IDAP REPORT

Property:	13 Gregory Street STRATHFIELD SOUTH Lot 3 in DP 201466 DA2021.98
Proposal:	Demolition of existing structures and construction of a two (2) storey dwelling house with basement, cabana, in-ground swimming pool, front fence and associated landscaping works.
Applicant:	BJ Architects International
Owner:	K. Qiu & C. Li
Date of lodgement:	5 May 2021
Notification period:	10 May 2021 to 24 May 2021
Submissions received:	2
Assessment officer:	G I Choice
Estimated cost of works:	\$950,000.00
Zoning:	R2-Low Density Residential - SLEP 2012
Heritage:	No
Flood affected:	Yes
Is a Clause 4.6 Variation Proposed:	No
RECOMMENDATION OF OFFICER:	Approval

Figure 2: Proposed basement plan

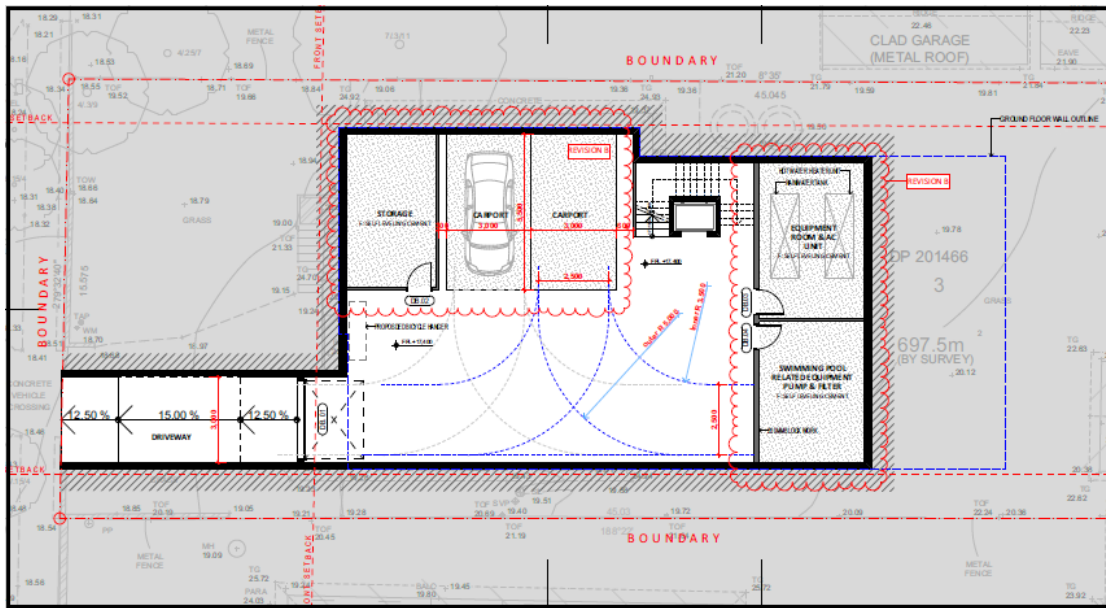
“All aspects of the off-street parking has been assessed against the AS2890 series and is considered satisfactory. Council's CDCP Part A Clause 8.1 requires excavation to be minimised to reduce disturbance to natural ground level. There appears to be opportunities to re-configure the basement layout to further reduce the basement area while still retain two on-site parking spaces and adequate manoeuvres. Consideration shall be given to basement reconsideration and reducing basement area.”

The amended basement design has deleted three (3) parking spaces and excessive turning area which was assessed as calculable floor area and contributed to an exceedance of allowable FSR. The reduced basement design with any spaces therein (storage, plant rooms etc.) are excluded from gross floor area calculations GFA (in accordance with the GFA definition in SLEP 2012).

Officer comment: The amended basement plan has substantially reduced the overall floor area and now provides two (2) parking spaces only.

Figure 4: Proposed first floor plan

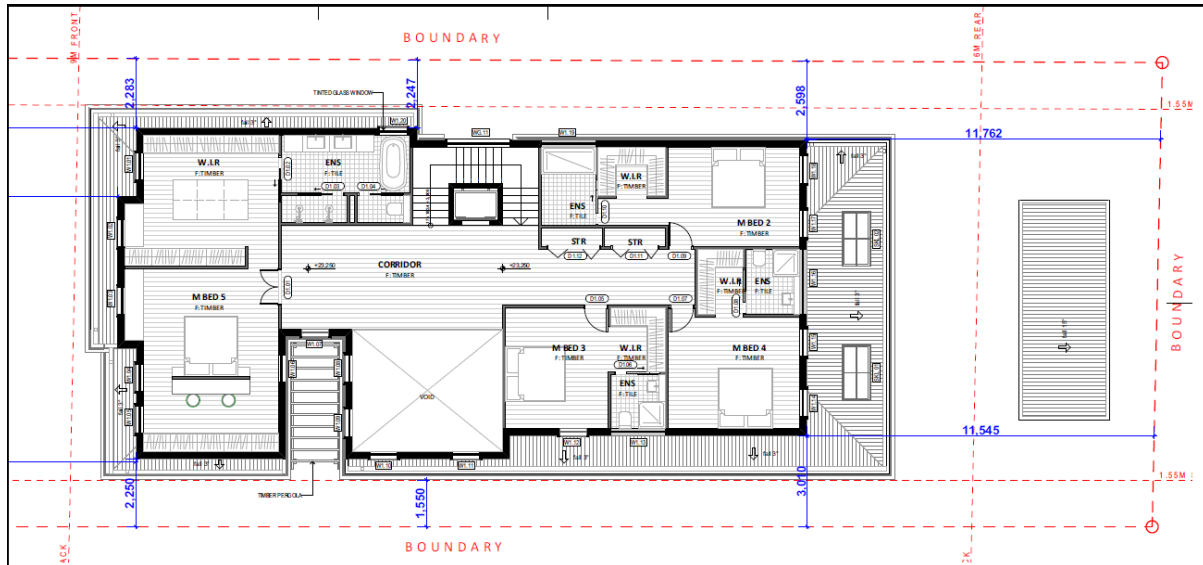
Comment: The proposed first floor plan includes a large void space along the east elevation which features two (2) six-pane centre panel windows. This is considered acceptable as the building design achieves sufficient articulation and modulation to reduce visual bulk by incorporating an increased first floor side setback (2.25m to 3.01m), open corridor feature and substantial glazing. It is noted that the proposed void will provide further amenity to the east-facing living room. Further, the area comprising the void will not result in significant overshadowing on adjoining properties.

Figure 16: Proposed TPZ & SRZ plan

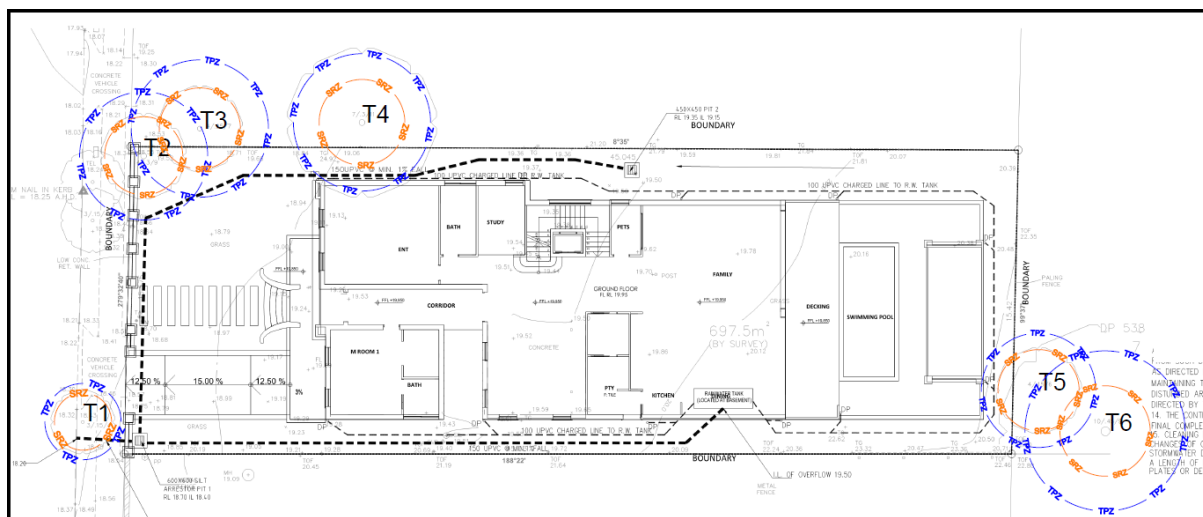
The proposal includes the removal of one (1) *Lagerstroemia indica* (Crepe Myrtle) street tree and one (1) *Brachychiton acerifolius* (Flame Tree) located on the south-west corner of the subject site (see **Figure 16**).

Officer Comment: The AIA has established that the proposed driveway improvement and new fencing cannot be realised without damaging Tree 1 and Tree 2.

Officer Comment: The area of deep soil zone on the subject site and adjacent verge is such that the planting of one (1) street tree and one (1) large canopy tree within the front setback is achievable.

Figure 17: Amended stormwater plan and tree canopy location (marked in green as nominated by Development Assessment Officer)

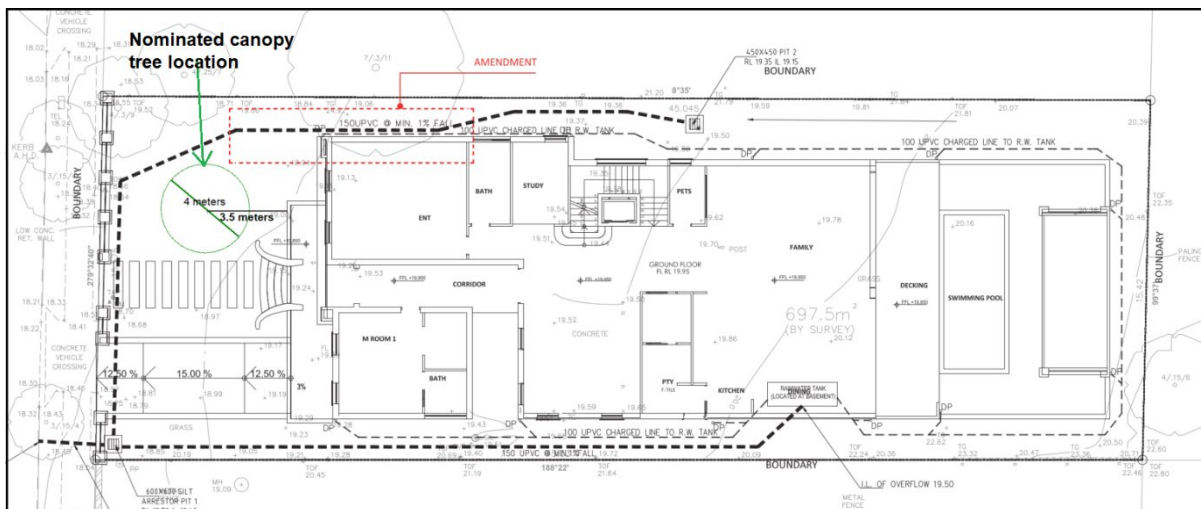
Officer Comment: Appropriate conditions for replacement planting are imposed so as to retain the amenity of the area. Generally, the trunk of a proposed canopy tree must be planted a minimum of 4m from built structures, or a minimum of 3m from pier beam footings. New trees must have a minimum setback of 3m from all boundaries, unless a species with non-invasive root system is proposed. A scaled assessment of the amended stormwater plan shows that a replacement canopy tree is achievable within the front setback. As shown in **Figure 17** below.

It is the Assessing Officers recommendation that the proposed tree removal and replacement planting are supported as the proposed development is considered to satisfy Clauses 4 and 5 of Part O SCDGP 2005.
